## HISTORIC PRESERVATION REVIEW BOARD STAFF REPORT AND RECOMMENDATION

Landmark/District: Address:	Anacostia Historic District 1348 Maple View Place	( <b>x</b> ) Agenda () Consent
	1	( <b>x</b> ) Permit
Meeting Date:	December 17th, 2021	( <b>x</b> ) Alteration
Case Number:	HP 21-371	() New Construction
		() Demolition
		() Subdivision

Owner Jade Moore, with plans prepared Olivia Akinsan, is returning to the Board for a threestory rear stair deck in the Anacostia Historic District.

Completed Rear Staircase and Deck from Chester Street

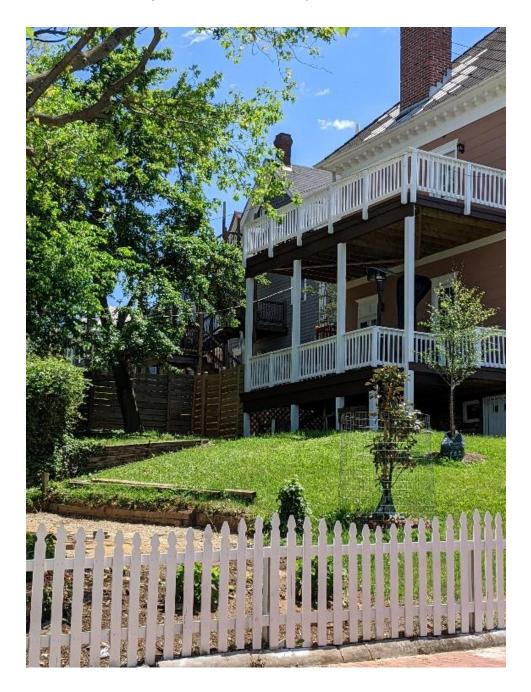
The applicant and architect have worked with HPO to make the corrections identified by the Board and to rectify the errors of the original contractor. While the second story deck is significantly extended from the rear elevation, it still is within the perimeters for a rear alteration where the Board has traditionally given greater flexibility. The addition of the metal railings and wood stain applied by the applicant lightens the appearance of the deck and helps blend it into the rear yards.

*HPO recommends the Board find this revised permit application compatible with the character and preservation guidelines of the Anacostia Historic District.*
